Product/Process Change Notice (PCN)		
<input type="checkbox"/> Major Change <input checked="" type="checkbox"/> Minor Change		
PCN Number: PCN_FrqSPXO_20250211 Affected Series: WE-SPXO Affected Part Number: 830205297709, 830208228309, 830205028309, 830208228609 PCN Date: 2024-11-11 (YYYY-MM-DD) Effective Date: 2025-02-11 (YYYY-MM-DD)	Change Category: <input type="checkbox"/> Equipment/Location <input checked="" type="checkbox"/> General Data <input type="checkbox"/> Material <input type="checkbox"/> Process <input type="checkbox"/> Product Design <input type="checkbox"/> Shipping/Packaging <input type="checkbox"/> Supplier <input type="checkbox"/> Software	
Contact: Product Management Phone: +49 (0) 7942 - 945 5001 Fax: +49 (0) 7942 - 945 5179 E-Mail: pcn.eisos@we-online.com	Datasheet Change: <input checked="" type="checkbox"/> Yes <input type="checkbox"/> No Attachment: <input type="checkbox"/> Yes <input checked="" type="checkbox"/> No

DESCRIPTION OF CHANGE: Because of a database mismatch, Würth Elektronik eiSos will correct the RoHs status (1), packaging details (2), product dimensions (3) and IQD Part No. format (4) in the datasheet. This is a datasheet correction only. There

3. Correction of the Product Dimensions:

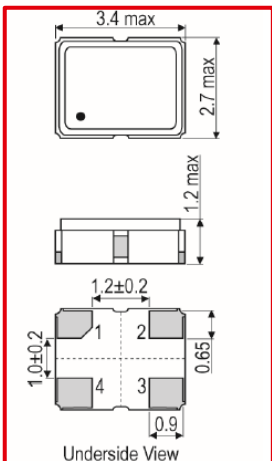
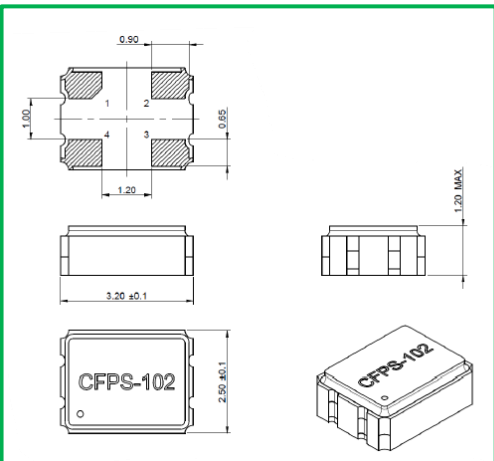
Before	After
Product Dimensions		
L	3.4 max	3.2 ± 0.1
W	2.7 max	2.5 ± 0.1
H	1.2 max	1.20 max
